# Groundwater Circulation Well (GCW) Technology Evaluation at the Massachusetts Military Reservation (MMR), Cape Cod, Massachusetts

June 1997

Air Force Center for Environmental Excellence (AFCEE)  
Technology Transfer Division

*Parsons Engineering Science, Inc.*

# CS-10 STRIPPER EFFICIENCY TCE REMOVAL FROM WATER

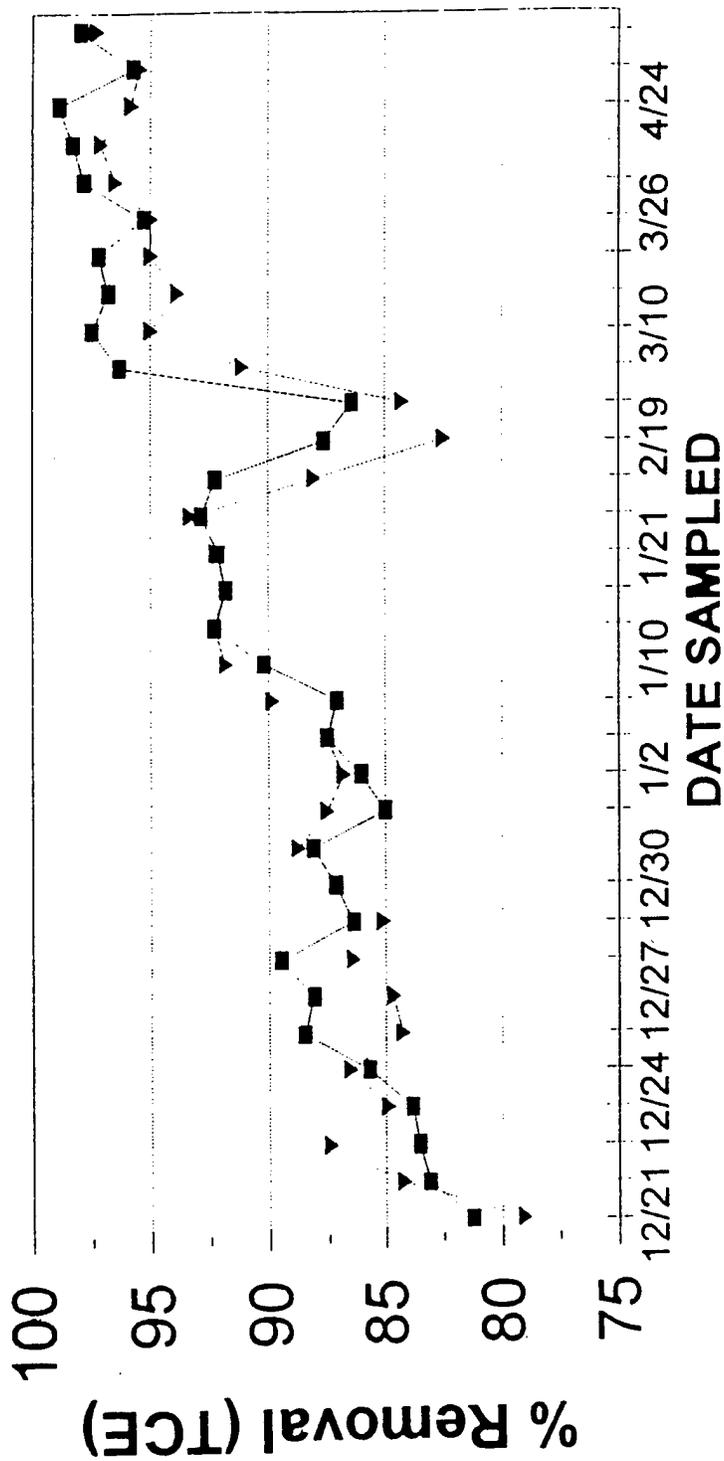
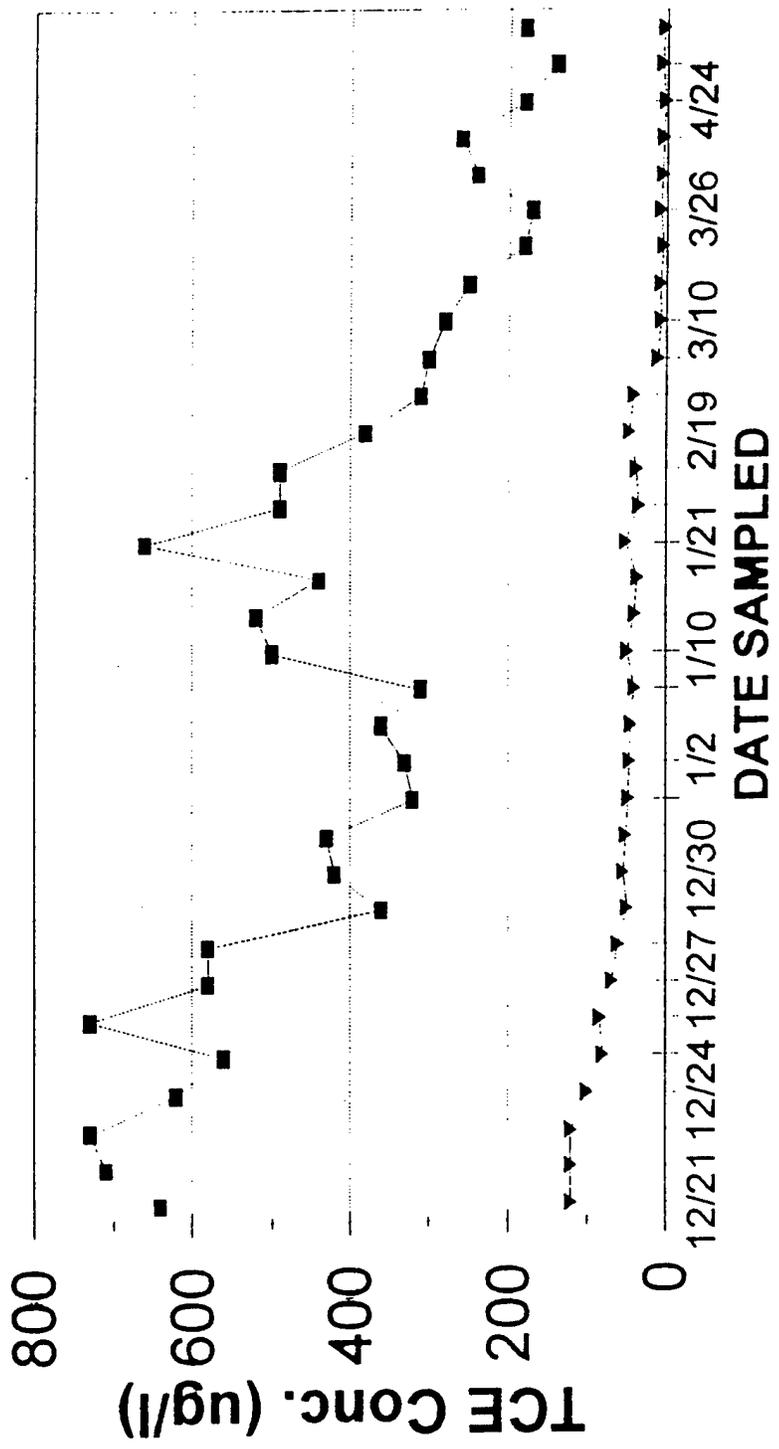
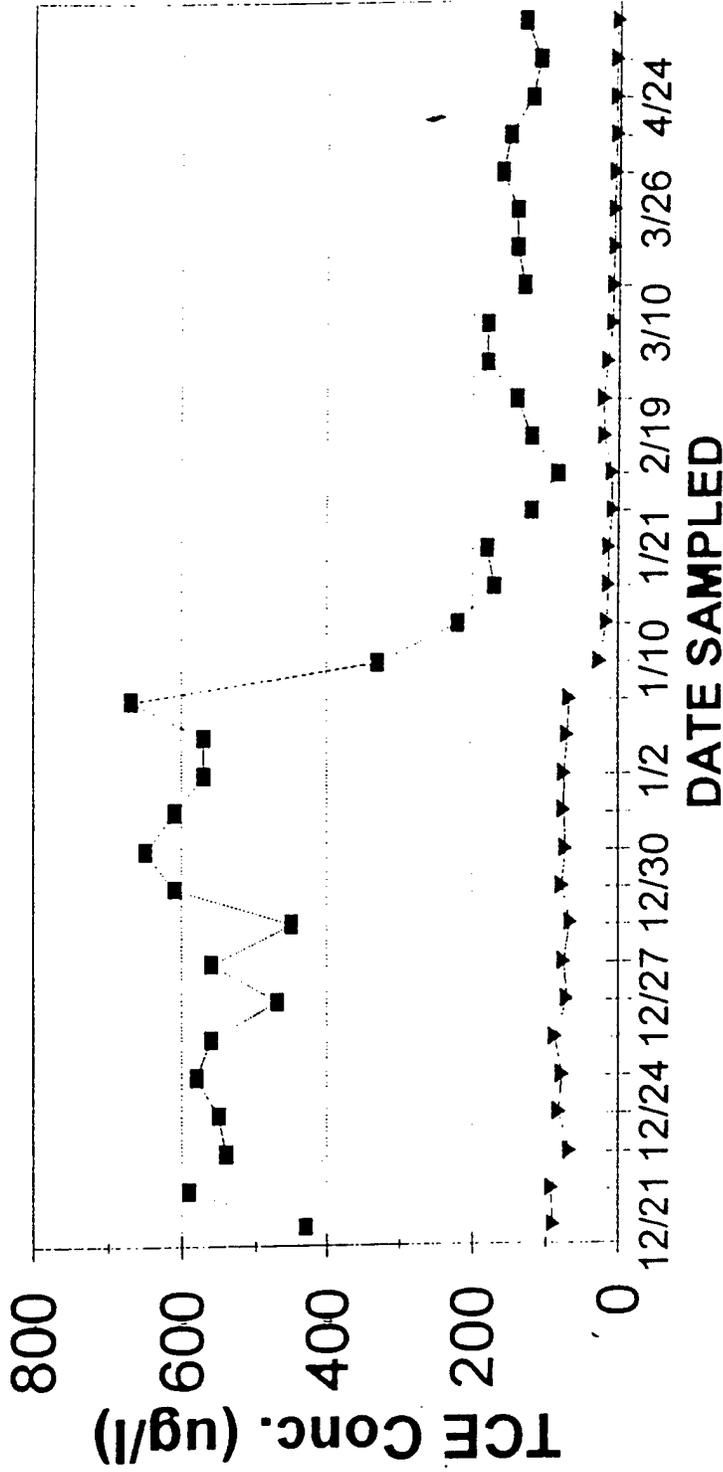
Unfortunately, at the NoVOCs site, located at the CS-10 South location, the initial two months of influent concentrations for the two circulation wells, 03RW0003 and 03RW0004, were not collected, making an evaluation of change in concentrations difficult. Influent TCE concentrations were available from weekly sampling from February 26, 1997 through April 24, 1997. The data suggests that the concentration of groundwater flowing to the circulation wells remained constant over the February to April sampling period. For example, the initial influent concentration of TCE measured on February 26 at the circulation well 03RW0003 was 940 ug/L. The influent concentration at this same well was 1200 ug/L on April 24. Influent concentrations at this circulation well, 03RW0003, ranged from a low of 520 ug/L on March 12 to a high of 1700 ug/L during the following week of March 5. At the other NoVOCs circulation well, 03RW0004, the initial TCE influent concentration was 520 ug/L on February 26 and was 570 ug/L on April 24. At this circulation well, 03RW0004, the influent concentrations ranged from a low of 380 ug/L on March 28 to a high of 710 ug/L on March 5. Since data was not available for the first 45 days of operation it is unknown if these concentrations represent a drop in the initial concentrations or not.

in the area of the intake area of the circulation well it does not provide support for vertical flow that is required for circulation. The panel did not find adequate support for the premise that, at the CS-10 UVB location, circulation of treated, effluent was occurring.

CONDITIONS INFLUENCING  
 ESTABLISHING RECIRCULATION

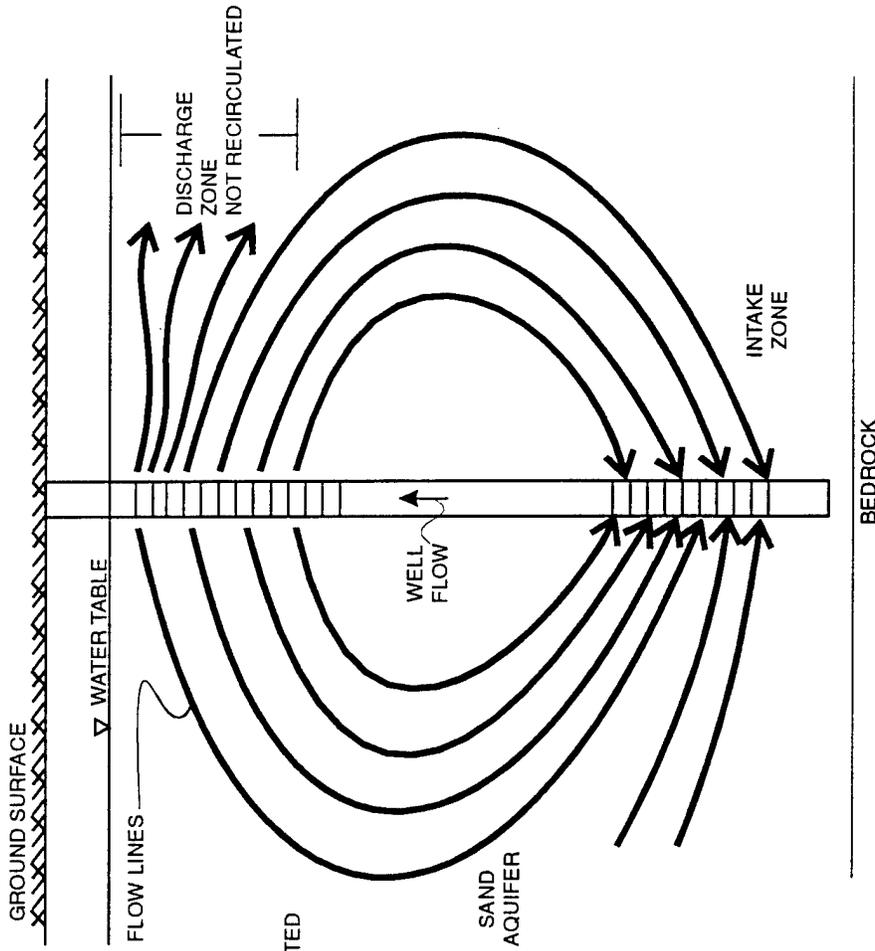
The pilot study piezometric data and the concentration changes in various wells were evaluated to determine if a circulation cell did exist. If the circulation cell did exist, then determining the extent of the circulation cell was of interest. The panel believed that neither the zone of capture nor the existence of a circulation cell could be proven with the existing data for any of the three demonstration sites. In presenting the data, both of the technology vendors believed that circulation flow was occurring, based upon the pressure data and observed changes in concentration. Groundwater modeling was used by the vendors to supplement this information and served as the basis for estimating the extent of circulation. Although the panel agreed that some of the data were consistent with development of a circulation cell, the same data were also consistent with an alternative hypothesis that no circulation cell had formed. The following figure provides an indication of the two possible occurrences. The panel agreed that if the circulation cells are closed, they very likely are not circulating at the design rate because the influent concentration appears to be on the order of twice as high as what would be expected if sufficient circulation was occurring. In order to achieve the target goal of MCLs, the system at the CS-10 location may require multiple circulation due to the low stripping efficiency. The figure provided on the following page depicts two possible cases that may be occurring at the circulation well sites at MMR. Case 1 depicts a condition where no circulation is occurring. Case 2 shows the system in operation as designed with multiple passes. With the current data, the panel could not determine which of these two cases were occurring. It is also possible that actual site conditions are somewhere in between the two cases illustrated in the figure.

If circulation is occurring, then the influent concentration of TCE at the circulation well is expected to decline over time as mass is removed. The panel considered the available data and concluded that the data did not strongly support circulation was occurring. This could be because the circulation

cells had not yet closed, but will eventually close. However, it is also possible that the circulation cells do not exist.
